COMBINED PRELIMINARY-FINAL SUBMISSION FOR NATIONAL CAPITAL PLANNING COMMISSION

EAST SHAFT PUMPING STATION REHABILITATION

WASHINGTON AQUEDUCT
MCMILLAN WATER TREATMENT PLANT, WASHINGTON D.C.

Looking northeast from Fifth Street sidewalk

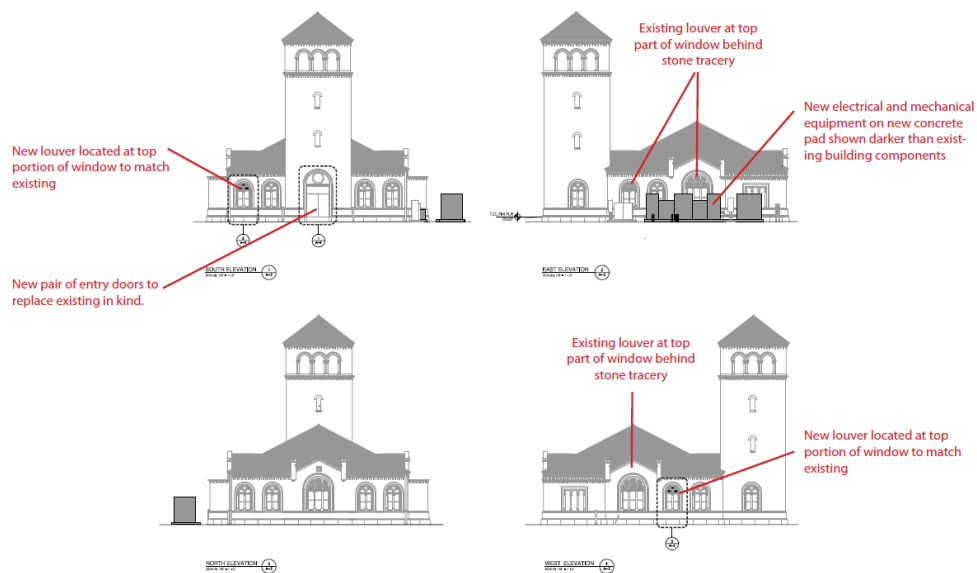
2. As for the newly proposed changes, we understand that a landscape plan has been developed but we continue to caution against locating vegetation too close to the primary elevation. The idea is to block views of the equipment rather than of the building. This may be especially problematic when the "Serbian Spruce" that is closest to the front, central tower reaches its full size (see Page 10 of the report). Smaller plants would seem to be sufficient nearest the tower.

3. Item 2: We discussed the concern about the Serbian Spruce evergreen growing to a size that covers the building façade. The intent was to use a spruce variety, maybe dwarf that did not grow any higher than 12'—even so the Landscape Architect acknowledges that this particular plant can be unruly. We also discussed the possibility of removing the Serbian Spruce altogether and allowing the Fosters Holly and Mug Pine to do the screening. We agreed that this will be left to the Landscape Architect to decide –with the shared understanding that exposing the full building facade is important.

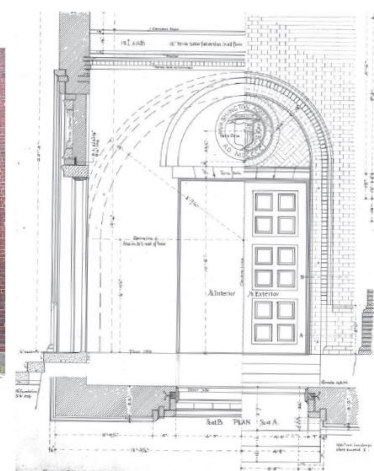
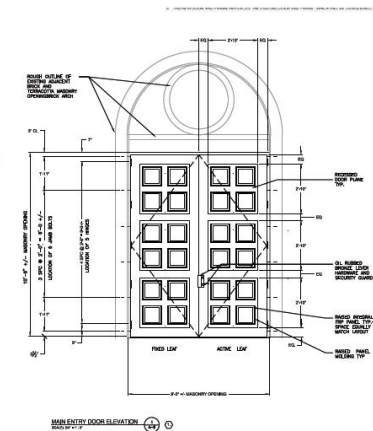
3. With regard to the proposed door replacement, we are not entirely convinced that the design of the existing door, or the door proposed in the 2002 rehabilitation plans, is historically accurate. Research suggests that the East Shaft Pumping Station was altered in the 1930s and while the c1938 drawing below suggests a multi-panel door similar to what is proposed in the report, it is difficult to determine whether that design was based upon historic conditions. Images of historic doors from other buildings at the McMillan Reservoir suggest a simpler design may have been used. Before completing our review of the door replacement project, we request the Army Corps of Engineers to check its files for any original drawings that may exist of the East Shaft Gate House so that we can be sure the final design is as historically accurate as possible.

4. Item 3: We reviewed the drawings received from the Washington Aqueduct of the entry doors. Happily these drawings are by the original building architect Macomb & Calvert, Philadelphia and appear to be dated circa 1901 judging from the roman numerals on the seal over the door. B&V will duplicate these elevations for the new proposed entry doors. The new doors are currently specified to be constructed of cast Fiberglass Reinforced Plastic (FRP)—the same material used for the existing entry doors. The fiberglass is specified for its durability and low maintenance properties. You expressed a strong preference that these doors be constructed of wood. We both agree that the original doors would have most likely been wood. The hardware is not detailed in the Macomb & Calvert drawings, so B&V will need to make an educated decision on modern hardware that most fits this older building.

PUMPING STATION ADDED LANDSCAPE PLANTING PLAN

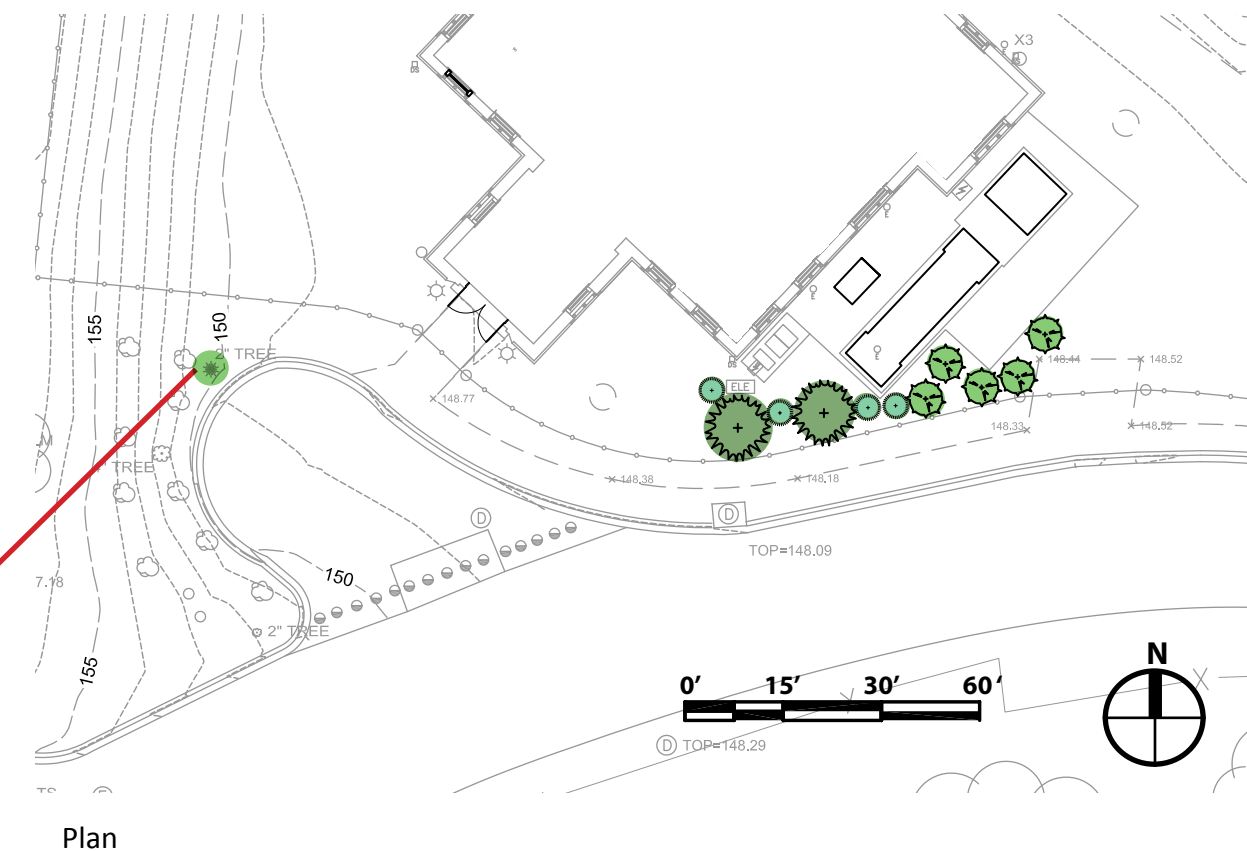
- He is looking for a plant species that integrates well with the existing landscape and is "strategically placed to divert the eye" (his words)
 - He is not looking for the plant screening to be quite as dense as shown in the rendering.
